M1074, M1075 PLS...

MUD FLAP HANGER KIT FLAP

M1074A1 and M1075A1 PLS...

HOW TO GET TWO-PIECE HYDRAULIC HOSE

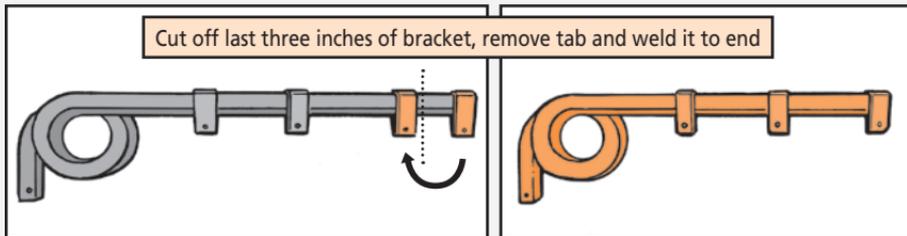
Mechanics, when you order a new mud flap hanger bracket kit, NSN 5340-01-383-2457, for your palletized loading system (PLS) truck, don't be surprised if the left- and right-hand brackets you get are a little longer than the originals.

These brackets are now made by two different vendors. The brackets made by the second vendor are about three inches longer than the originals.

If you receive the longer brackets, you'll need to modify them. Just cut off the last three inches of both brackets. Then remove one clip from each bracket so that only three clips remain. Weld the end clip flush to the end of the hanger.
